AMENDMENTS TO THE DRAWINGS

REMARKS

FIG. 6

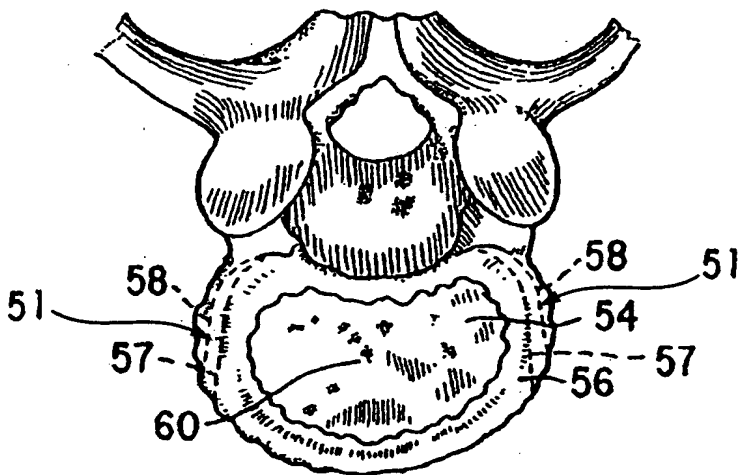
Please amend Fig. 6 as shown in redline in the Marked-Up Version attached.
A clean copy of the Replacement Drawing is also enclosed.

The specification and drawings are presently amended since it was noted that the numeral 50 was unintentionally used to designate two different elements, and that the lateral sides of the vertebra had inadvertently not been numbered in Fig. 6. The amendment renumbers the lateral sides of the vertebra with numeral 51, and these numerals have been appropriately added to Fig. 6. These amendments are fully supported, for example in the amended paragraphs themselves, on pages 9 and 13.
